KILRUBIE WINDFARM (DIO23034) WIND FARM DEVELOPMENT PROPOSAL - NO OBJECTIONS DESPITE LOS

WR80026/01

DIO 23034 - AIR TRAFFIC CONTROL (ATC)

PROPOSAL TO ESTABLISH KILRUBIE

Figure 2

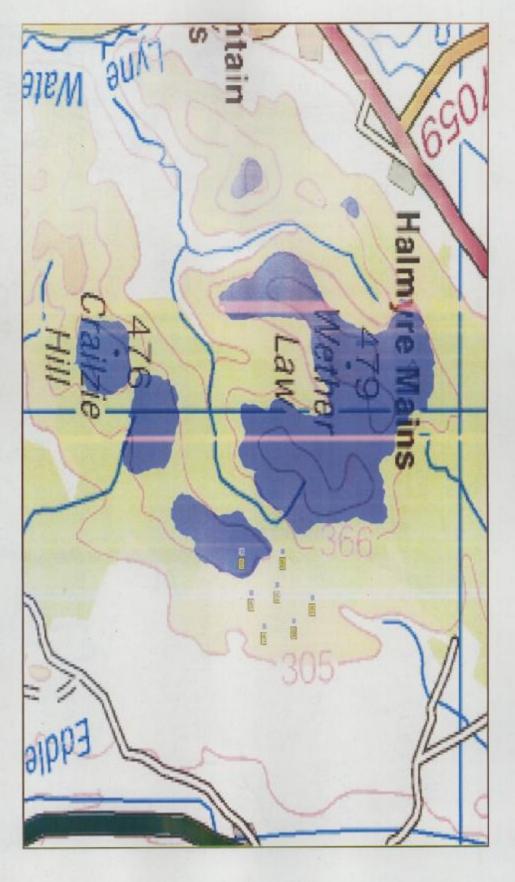
- 4.1.2 A Field Strength Coverage plot was generated for the radar using these parameters (Figure 2), indicating that one of the turbines (t4) will be detected by the radar.
- 4.1.3 All other radars at this site have been checked.
- 4.2 There are no concerns regarding the following radars, which have been checked:
 - 4.2.1 RAF Leuchars, Berry Hill
 - 4.2.2 ASACS Brizlee Wood, Staxton Wold, Buchan, Benbecular
 - 4.2.3 MAA Warton
 - 4.2.4 NATS Great Dun Fell
- 4.3 The proposed wind farm is beyond the protected range and/or outside the protective arcs of all other radars.

It is recommended that the Operations Staff check whether the proposed Kilrubie Windfarm is in an area of vital air traffic operations controlled by the radar at Deadwater Fell. If so a decision to object to the proposal should be considered on the grounds referred to in paragraph 3.1 and paragraph 3.2.
